**Blackmoorfoot Road, Huddersfield  
Proposed Access Arrangements  
Stage 1 Road Safety Audit**

May 2025 (Rev 1)

**Miller Homes & Vistry Homes Limited**

Report title	Stage 1 Road Safety Audit
Date	8 <sup>th</sup> May 2025
Document reference and revision	250508 Initial Issue
Prepared by	Optima Highways
On behalf of	Kirklees Council

**Table 2.6 Problem 6**

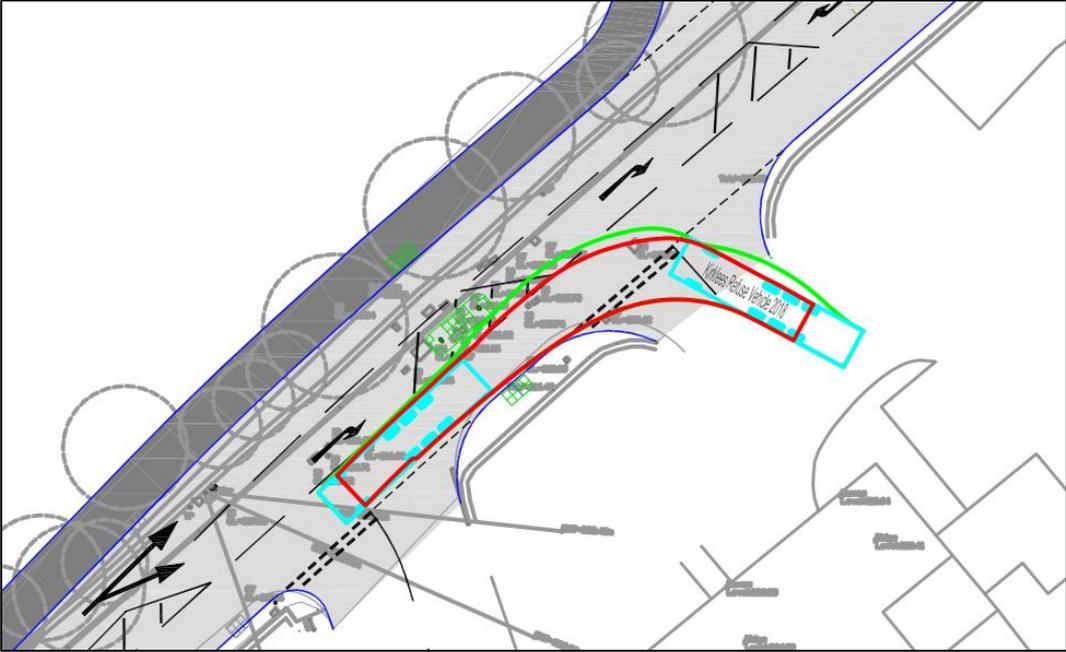
PROBLEM	
<b>Location</b>	Blackmoorfoot Road – Public House access.
<b>Summary</b>	Potential for refuse/delivery vehicles overrunning the pedestrian refuge island.
<p>A swept path analysis is provided of a Kirklees refuse vehicle turning left out of The Sands House public house onto Blackmoorfoot Road.</p> <p>The analysis indicates that the manoeuvre is extremely tight, with minimal margin for error, due to the proximity of the proposed pedestrian refuge island located between the public house access and Sands House Lane. Based on the analysis presented, there appears to be a risk that larger vehicles could overrun or collide with the refuge island.</p> <p>Furthermore, the assumed starting position and orientation of the vehicle may not be practically achievable when considering the internal layout of the public house and the location of the bin store. In reality, larger vehicles may adopt an alternative exit path, which may increase the likelihood of a vehicle overrunning or striking the refuge island, resulting in a potential vehicle/pedestrian collision or damage to the street furniture.</p> <p>It is worth noting that the analysis adopts an inconsistent approach, with the right turn entry movement showing the vehicle travelling to the western frontage of the site, whereas the exit assumes an origin from the rear of the public house.</p>

<b>Recommendation</b>	
<p>It is recommended that the swept path analysis is revisited to ensure the exiting vehicle is realistically positioned and oriented. Following the revised analysis, should the swept path impact on the proposed refuge island, it is further recommended that the island be repositioned or redesigned to ensure all vehicle movements can be comfortably accommodated.</p>

Table 2.7 Problem 7

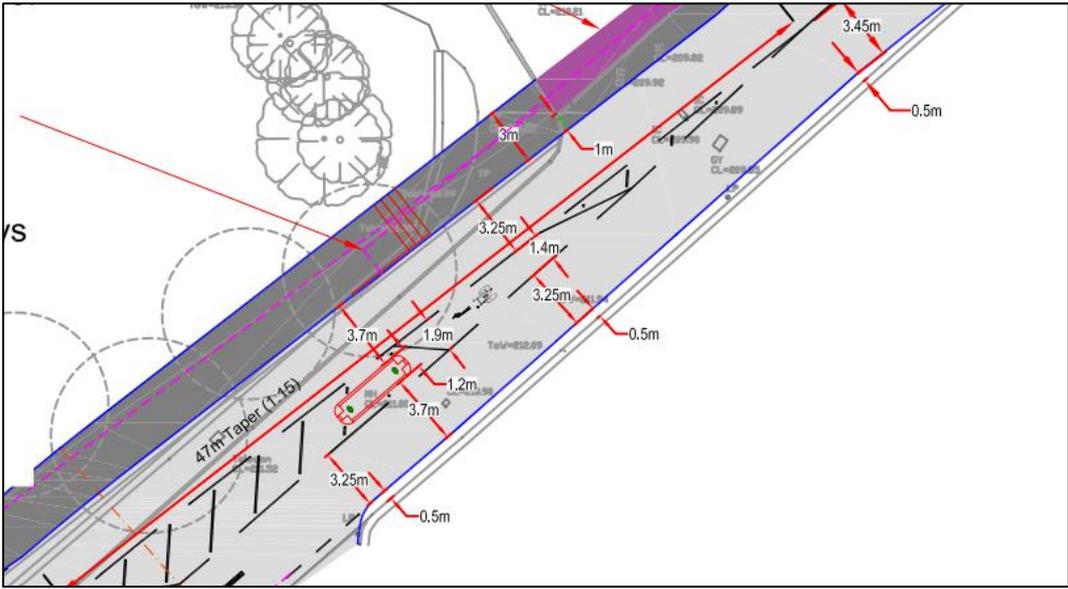
PROBLEM	
<b>Location</b>	Blackmoorfoot Road access.
<b>Summary</b>	The splitter island may result in vehicle/cyclist collisions.
<p>The proposed design includes a 1.2m wide splitter island intended to protect cyclists turning right from Blackmoorfoot Road into the development. Through lanes of 3.7m are provided adjacent to the splitter island.</p> <p>Guidance contained within LTN 1/20 and Chapter 6 of the Traffic Signs Manual 'Traffic Control' state that lane widths between 3.2m and 3.9m should be avoided as it can encourage drivers to attempt unsafe overtaking of cyclists, when there is insufficient space to do so.</p> <p>Whilst the Road Safety Audit Team agrees that the splitter island is an important feature of the scheme, as a consequence, westbound and eastbound cycle traffic could be 'squeezed' by drivers misjudging the passing clearance, resulting in a potential vehicle/cyclist collisions.</p>

<b>Recommendation</b>	
<p>The Road Safety Audit Team's preferred option would be to provide lane widths of 4.0m past the splitter island, consistent with the pedestrian refuge island opposite the public house. However, the Overseeing Organisation has confirmed that this is not feasible, due to the resultant impacts on either the taper length or the right turn lane length.</p> <p>As such, it is recommended that either the right turn cycle facility and island are removed or additional measures are provided to discourage overtaking such as widening the island, providing red thermoplastic surfacing within the central hatching on both the approach to and around the island (to visually reinforce the through lane width), provide road markings (cycle symbol for example) past the island to indicate a cyclists expected road positioning or whether warning signage could be provided.</p>

Table 2.8 Problem 8

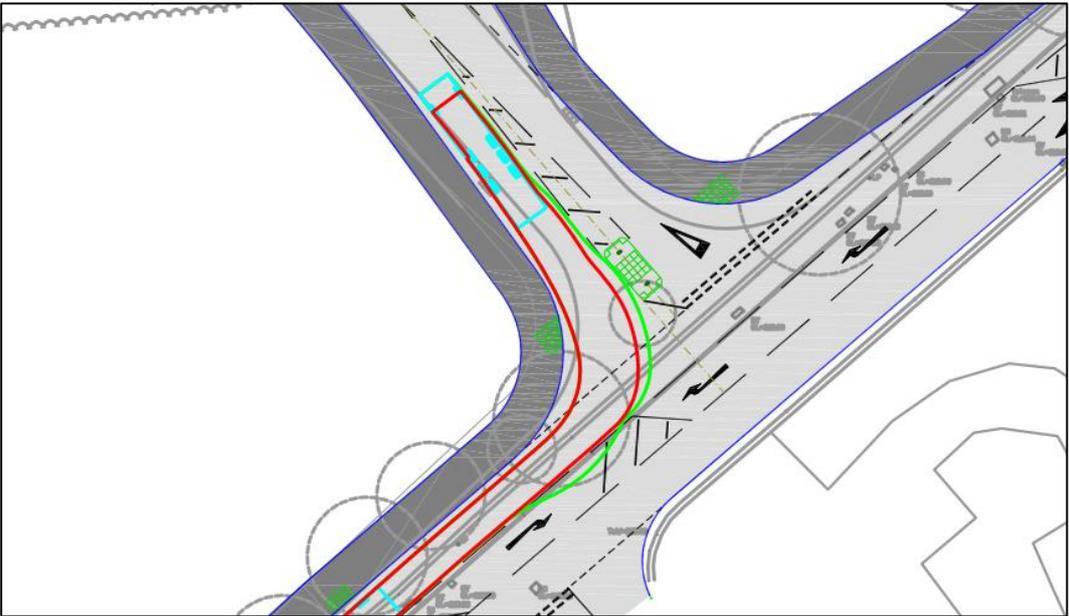
PROBLEM	
<b>Location</b>	Blackmoorfoot Road access.
<b>Summary</b>	The width of the pedestrian refuge island may result in vehicle/cyclist collisions.
<p>The side arm of the junction includes a 2.0m wide pedestrian refuge island, connecting to a 3.0m wide shared footway/cycleway along Blackmoorfoot Road. The Road Safety Audit Brief states that the reduced width of the island has been provided in order to minimise tree loss.</p> <p>The swept path analysis confirms that both buses and refuse vehicles entering the development require the full width of the lane, with minimal margin for error, passing in very close proximity to the island.</p> <p>Although the Road Safety Audit Team acknowledges that use of the island by larger bicycles may be limited, there is concern that the narrower island width could lead to vehicles encroaching on cyclists using the island, if a cyclist (particularly a less experienced rider) does not position themselves entirely within the island, increasing the risk of a vehicle/cyclist collision.</p>

<b>Recommendation</b>	
It is recommended that the island is increased to 3.0m in accordance with LTN 1/20 guidance.

**Table 2.9 Problem 9**

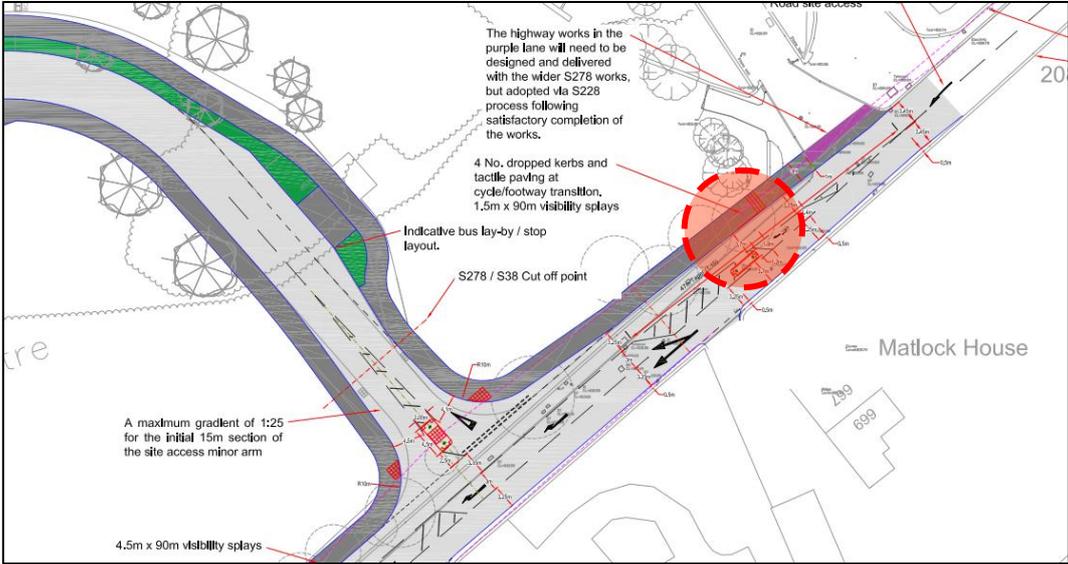
PROBLEM	
<b>Location</b>	Blackmoorfoot Road access.
<b>Summary</b>	Lack of advisory cycle lane road markings
<p>A dropped kerb, tactile paving and advisory cycle lane road markings are provided to the west of the junction to denote the start of the shared footway/cycle provision. At the end of the shared footway/cycle, dropped kerbs and tactile paving are provided, however the advisory cycle lane markings have not been provided (consistent with the Felks Stile Road junction).</p> <p>The provision of a short length of advisory cycle lane, raises awareness of the likelihood of a cyclist entering the carriageway, therefore the absence of the road markings could increase the potential for a cyclist being struck by an oncoming vehicle, discharging into the carriageway.</p> <p>Although it is acknowledged that this is a preliminary design, the use of tactile paving at the start and end of the shared facility, rather than corduroy, may cause confusion for visually impaired users by failing to distinguish between pedestrian and cycle routes.</p>

<b>Recommendation</b>	
<p>It is recommended that a short length of advisory cycle lane road markings are provided at the end of the shared footway/cycleway and that the tactile paving is stipulated corduroy paving at the detailed design stage.</p>
